**From:** Philip McLaughlin <pmclaughlin@eis1.net>  
**Sent:** Thursday, August 24, 2017 4:00 PM  
**To:** Detterman, Mark, Env. Health  
**Cc:** Roe, Dilan, Env. Health; plittman@eis1.net; 'Tom Graf'; 'Bridget Galka'  
**Subject:** RE: 1228 - 1236 E. 17th Street Redevelopment (RO3243); Questions on Work Plan  
**Attachments:** Figure 3 - Proposed Boring Location Map.pdf

**From:** Detterman, Mark, Env. Health [mailto:Mark.Detterman@acgov.org]  
**Sent:** Wednesday, August 16, 2017 3:13 PM  
**To:** 'Philip McLaughlin' <pmclaughlin@eis1.net>; 'plittman@eis1.net' <plittman@eis1.net>; 'Tom Graf' <tom@grafcon.us>; 'Bridget Galka' <bgalka@Oakha.org>  
**Cc:** Roe, Dilan, Env. Health <Dilan.Roe@acgov.org>  
**Subject:** 1228 - 1236 E. 17th Street Redevelopment (RO3243); Questions on Work Plan

**Soil Boring Location Map**

1228, 1232, and 1236 E. 17th Street, Oakland, California

**Figure: 3**  
EIS Project: I652-2A  
June 27, 2017

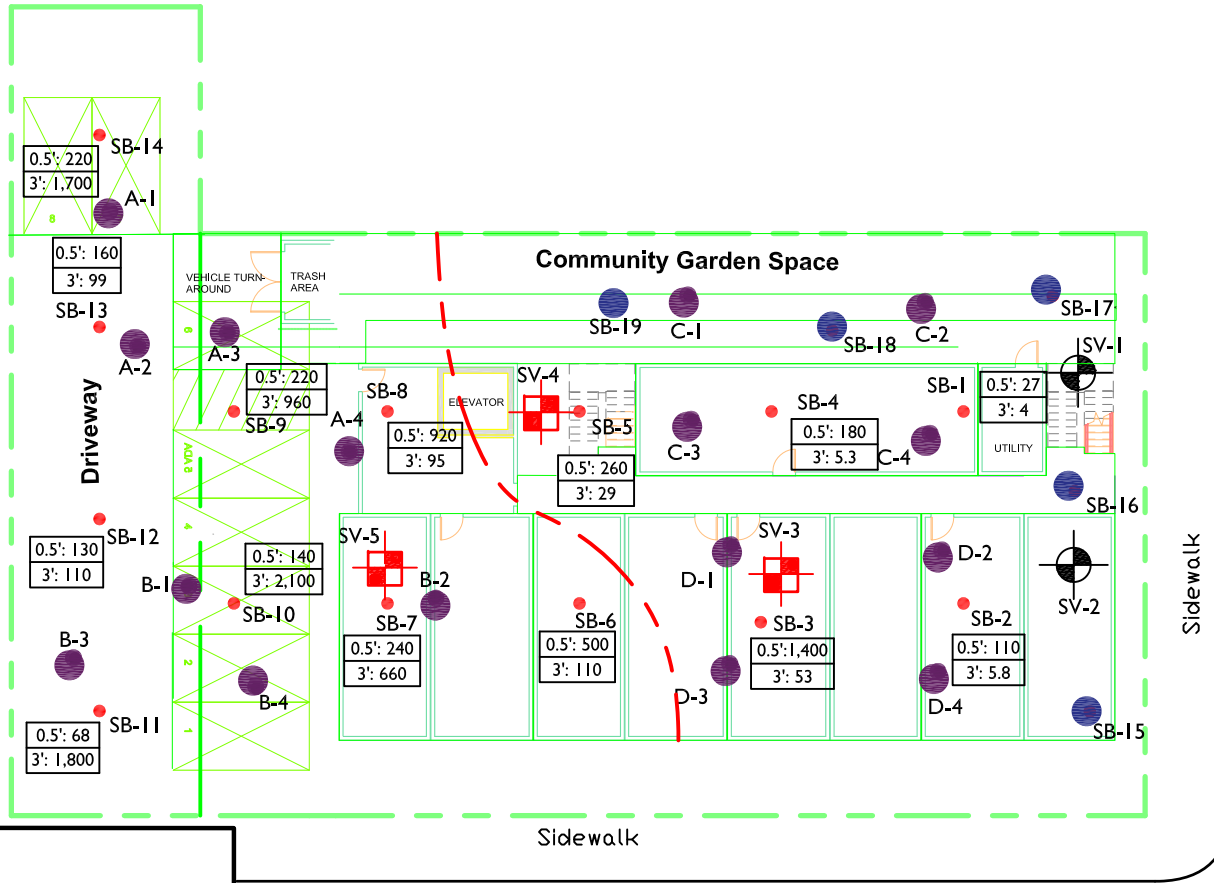
1. **Site Cut / Fill and Surplus Soil Management** – I recall that soil from beneath lead contaminated soil in the central portion of the site will be excavated and either reused onsite, or off-hauled as potentially clean fill to another site, and that the overlaying lead contaminated soil will be replaced into the hole created, and subsequently capped beneath the proposed concrete slab for the redevelopment. Please clarify this. It is additionally understood that the A- and B-series soil bores which are proposed to be composited in the laboratory, will be analyzed for TPHg, TPHd, TPHmo, PAHs, and CAM17. What is the intended use of this soil? Will this be off-hauled, or used as fill beneath the proposed concrete slab cap? If we are concerned about the listed contaminants in one area of the site for onsite reuse, are we not interested in them below the future concrete slab cap at the remainder of the site?

- 2. Clean Fill Characterization** – As indicated, potentially clean soil beneath lead contaminated soil in the central portion of the site will be excavated for one of several reasons. How will the limits of that soil be defined? At present the majority of three foot soil samples contain lead above the residential lead ESL of 80 milligrams per kilogram (mg/kg), and thus the lower extent of soil contaminated with lead has not been defined. Do you intend on defining upper and lower (depth) low lead concentrations prior to excavation (preferred), or with clean upper confirmation samples concurrent with excavation, and post-excavation lower confirmation samples? The addition of soil bores to characterize this now would be one way to proceed. (I can request in an approval letter, if this is how you would like to proceed, rather than another work plan modification, but if you intend to do another way, let me know.)

Below I've provided response and clarification to your comments in blue text. I've attached a revised Figure 3 depicting additional C- and D-series borings in the eastern half of the Site for collection of composite samples to be analyzed for additional contaminants as previously proposed for the western half. Please let me know if you have any further comments or questions. We are prepared to modify the existing Workplan to incorporate the clarification and revisions discussed below.

Regarding your question about our sampling for potential additional contaminants (TPH-g/d/mo PAHs, CAM 17 metals) in the western half (composite samples from A- and B-series borings), but not in the eastern half, upon further consideration we will revise our sampling plan to collect similar samples in the eastern half for consistency across the Site. The analysis of screening-level composite samples is intended as an additional level of assurance that other potential contaminants are not present in soils to be graded across the site. We propose to advance four C-series borings in the northeastern quadrant of the Site and four and D-series borings in the southeastern quadrant (see attached figure). Single samples will be collected from each of the borings at a depth of approximately 1.0 feet bgs, with the samples organized in the laboratory into two 4-point composite samples representative of the uppermost soils in the eastern half. As noted above, during grading activities the uppermost 1 to 2 feet of soil having lead impacts will be scraped away from the eastern half and temporarily stockpiled on the western half to await over-excavation of the eastern half, after which lead-impacted soils will be flopped over into the excavation from the western half.

Based on soil data collected to-date, the soil beneath the lead-impacted soil in the eastern half appears to be "clean" below a depth of approximately 2 feet bgs (3-foot bgs samples have low, below-ESL lead concentrations). Once the uppermost lead-impacted soil is scraped-away and stockpiled separately on the western half, a grid of discrete subsurface samples would be collected and composited from the eastern half as described above, with the samples analyzed for appropriate parameters to pre-profile the soil to be excavated for ultimate landfill acceptance. EIS is considering using an XFR lead analyzer during grading activities to confirm that the cut is deep enough to remove soils with significant lead impacts and thereby assure that off-hauled soil can be disposed in a Class III landfill, or if suitable, reused as clean fill at another construction site. Use of the XRF analyzer concurrent with the excavation is proposed instead of actual confirmation samples to define the upper boundary of soils to be disposed in a Class III sanitary landfill, or if suitable, reused as clean fill on another construction site. Post-excavation confirmation samples from the bottom of the excavation are not considered appropriate to confirm vertical attenuation of lead to below ESL (or background levels), as the entire site is to be capped by the mat foundation and hardscape. As noted above, pre-profile sampling of the soil to be off-hauled would be performed as part of a corrective action plan to be implemented during grading activities.
